Please find attached a submission on behalf of Cornish Group in response to the proposed Western Sydney Aerotropolis Stage 1 Land Use and Infrastructure Implementation Plan.

**RE: SUBMISSION: PROPOSED ZONING FOR STAGE 1 PLAN FOR THE
WESTERN SYDNEY AEROTROPOLIS**

The Cornish Group site to which these comments relate, is situated at [REDACTED] Luddenham. The Site sits within the Northern Gateway Precinct, within the draft Western Sydney Aerotropolis (WSA) area. The rear of the lot backs on to Cosgroves Creek - a 4th order stream and whose classification as such, provides support for part of Cornish Group's revised zoning proposal herein.

Figure 4: Excerpt from Guidelines for riparian corridors on waterfront land – NSW Department of Primary Industries Office of Water.

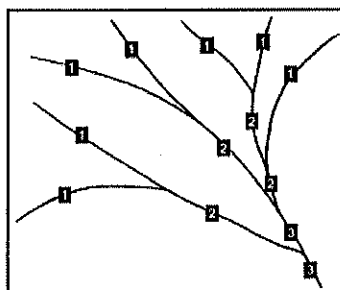
However, it is also noted, that as a 4th order stream, Cosgroves Creek will require a 40m Vegetated Riparian Zone to observe the guidelines for riparian corridors on waterfront land as prescribed by the NSW Department of Industries Office of Water (See Figure 4 below).

The application of the recommended riparian corridor widths shown in Figure 4 above to Cosgroves Creek, would provide a 100m wide corridor which we believe is more than sufficient to achieve the objectives of the waterway planning principles of Greater Sydney Commission's Western City District Plan, noted above.

Cornish Group therefore submits that a zoning classification of Water Management for such areas, would concurrently observe the Office of Water recommendations for riparian corridors and better achieve the objectives of the Greater Sydney Commission's Western City District Plan.

Figure 6: Flooding Extents – 100-Year ARI (Average Recurrence Interval) & PMF (Probable Maximum Flood)

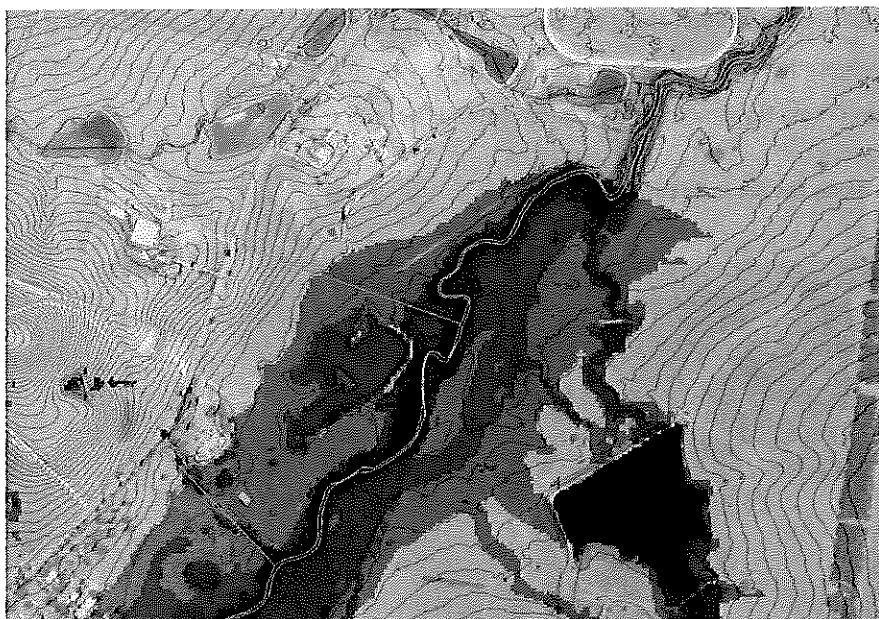
Based on the mapping presented in the draft WSA exhibition documents, the proposed Non-Urban zone appears to adopt the extent of the Probable Maximum Flood (PMF) inundation zone and is therefore inconsistent with the Employment Land use planning controls applied to these types of areas.

Further support in the adoption of a 1 in 100-year ARI zone mapping tool in favour of a PMF, is provided by the development footprint afforded by each. After the WSA proposed PMF extents have been taken into account, the development footprint is less than 80m wide in some parts of the site. This is due to the PMF being selected as the limit for development but is also exacerbated by the fact that there is an existing farm dam on site which, once removed will result in reduced flood extents.

With a development provision of less than 80m in some parts of the site, the proposed WSA, PMF based zone mapping is not consistent with the spatial requirements for Employment Land zones and prevents the site from realising its potential highest and best use as a source of employment.

Consequently, Cornish Group recommends implementation of accepted and importantly, *contextually appropriate* Floodplain Development Controls to The Site and as such, that the 1 in 100-year ARI flooding extent is adopted as the principle mapping tool for land use zoning purposes.

Specifically, the revised coverage of Flexible Employment zoning should extend down to Cosgroves Creek to a distance which is equal to the *greater* of:

- a 40m wide Vegetated Riparian Zone;
- the 1 in 100-year ARI flood extent;
- the extent of existing significant ecological communities.

The practical outcome of adopting recommendations (1) and (2) above is illustrated in [Figure 7](#), below. The contrasting application of the draft zoning measures currently being considered, is illustrated in [Figure 8](#)

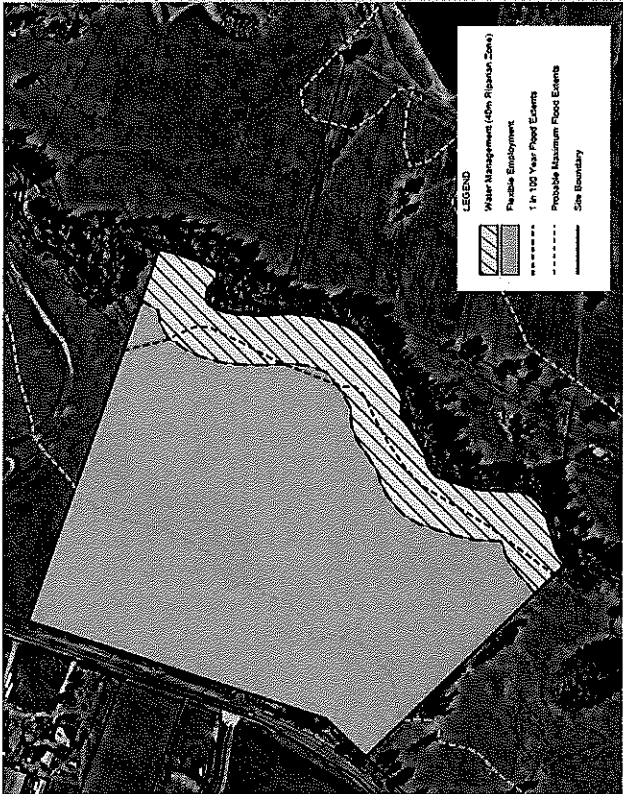
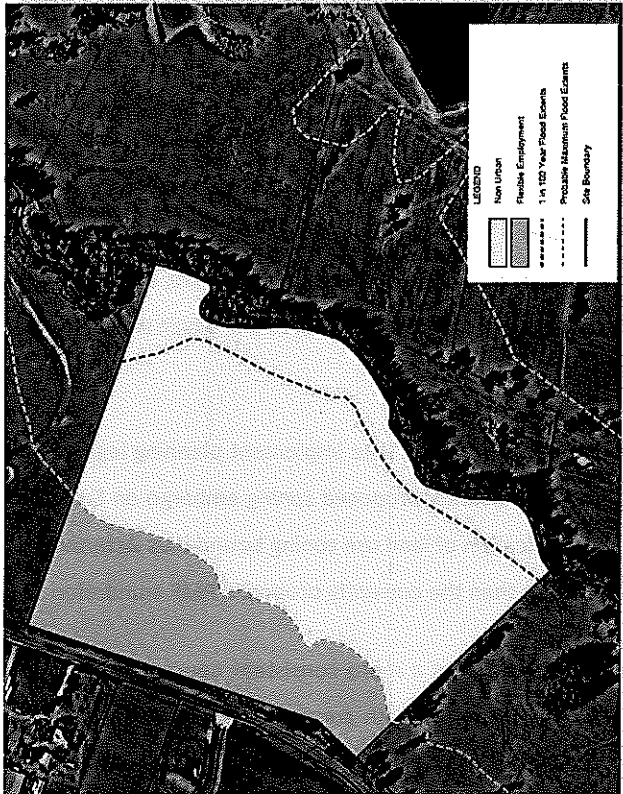
The image above illustrates that the application of the current, draft Flexible Employment (adopting PMF levels) and Non-Urban zoning.

Cornish Group's second recommendation is to implement planning legislation to the Aerotropolis, whose effect is to reduce the currently proposed zoning embargo on Employment Lands. This can be achieved through the application of land use zoning boundaries determined by 1 in 100-year ARI flood inundation levels, rather than the currently proposed PMF inundation areas.

The image above illustrates that the application of revised Flexible Employment zoning and Water Management (rather than Non-Urban) zoning.
